## **Wheeler Fieldhouse**

**Accessibility Review**

**Photo 1:** View of accessible parking. Re-stripe to provide an 8' wide access aisle. (Can be shared between 2 spaces.)

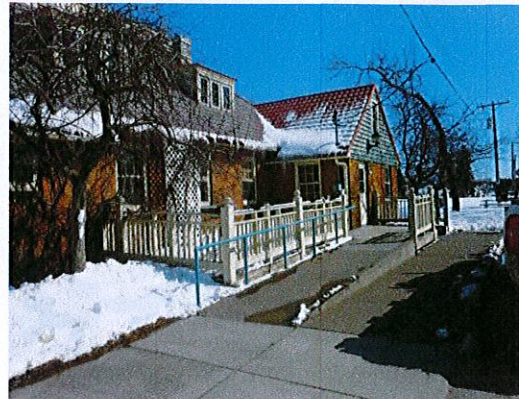
Location JQP # / Item #	Solution / Comments	Qty	Unit Cost	Total Cost	Priority	Estimated Compl. Date	Person Responsible	Actual Compl. Date	Actual Cost
<b>Men's Toilet Room</b>									
22B 16110	Install signage with appropriate raised and Braille lettering. MN 1341 1110.2	1	\$40	\$40	3				
22H1 16118	Provide staple style pulls on both sides of the accessible stall door near the latch. ANSI 604.8.3	1	\$50	\$50	3				
22J 16117	Provide stall door hardware that does not require grasping, pinching or twisting to operate. ICC ANSI 309.4	1	\$50	\$50	3				
22K6 (MN) 16115	Remove the existing grab bar configuration and replace with a compliant grab bar configuration. MN 1341 604.5.1 ANSI 604.5.2	1	\$400	\$400	3				
22Q 16112	Insulate or otherwise protect exposed pipes at lavatory. ICC / ANSI 606.6	1	\$50	\$50	3				
				<i>Location Subtotal:</i>					\$590
<b>Parking</b>									
05H 16104	Stripe to provide an accessible parking stall that is 8' wide with an adjacent 8' access aisle. It is preferred that the access aisle be located on the passenger side of the vehicle. MN 1341 502.4.2  <i>There are currently 3 spaces designated as accessible- each 9' wide with an adjacent 5' wide aisle. Re-stripe so each space is 8' wide with an adjacent 8' wide aisle (aisle can be shared between 2 spaces). Photo 1.</i>	3	\$150	\$450	3

**Photo 3:** Relocate the bench; it currently obstructs access to the drinking fountain.

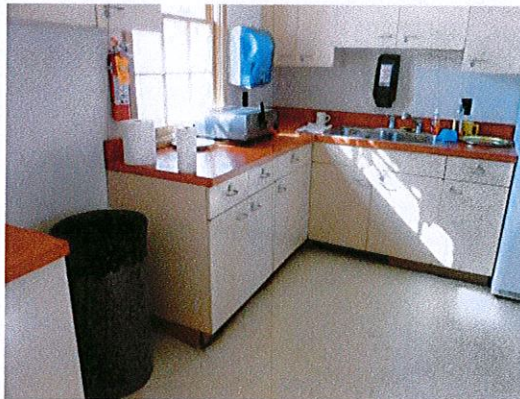
Location JQP # / Item #	Solution / Comments	Qty	Unit Cost	Total Cost	Priority	Estimated Compl. Date	Person Responsible	Actual Compl. Date	Actual Cost
<b>Drinking Fountain</b>									
16121	<i>Relocate the bench that currently obstructs the clear floor space at the drinking fountain. Photo 3.</i>	1	\$0	\$0	3				
41A1 16120	Provide a minimum of one drinking fountain that has a 36" spout height accessible for persons using wheelchairs (low) and one standard height (high) drinking fountain with a spout height 38" minimum and 43" maximum for persons who have difficulty bending or stooping. ANSI 602.4 <i>There is currently 1 drinking fountain with a 33" spout height.</i>	1	\$1,500	\$1,500	3				
				<i>Location Subtotal:</i>					\$1,500
<b>Gathering Room</b>									
14G1 16109	Eliminate protruding hazard by installing end panels or other object to direct a person with visual impairments using proper cane technique around the potential hazard. ICC / ANSI 307.1 <i>The mantle of the fireplace currently protrudes 10" at a height of 57".</i>	1	\$200	\$200	3

**Photo 6:** The entry to the men's toilet room does not currently provide maneuvering clearance. Propping the door in the 'open' position is a good example.

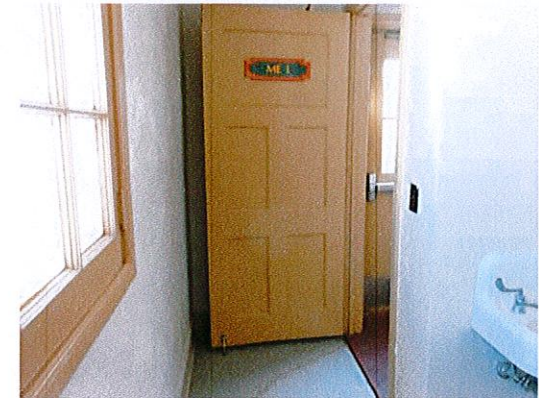
<i>Location Subtotal:</i>					\$2,500
<b>Men's Toilet Room</b>									
22-20C 16111	Relocate door and frame to provide needed maneuvering clearance at the door. ICC / ANSI 404.2.3, Table 404.2.3.1 <i>The depth at the door is currently 41" (vs. 48" minimum). The door was propped in the 'open' position at the time of site visit. Photo 6.</i>	1	\$1,500	\$1,500	4				
22G (MN) 16114	Modify to provide a minimum clearance of 48" in front of the water closet. MN 1341 604.3.1 <i>The stall is currently 5' x 5'. Photo 5.</i>	1	\$1,000	\$1,000	4				
22M 16116	Provide a water closet with a seat height 17"-19" above the floor. ANSI 604.4 <i>Currently at 16 1/2".</i>	1	\$750	\$750	4				
22P 16113	Raise the lavatory to provide a minimum knee clearance height of 27". ICC / ANSI 606.2 <i>The wall hung sink currently provides 26" knee clearance.</i>	1	\$1,000	\$1,000	4				
				<i>Location Subtotal:</i>					\$4,250
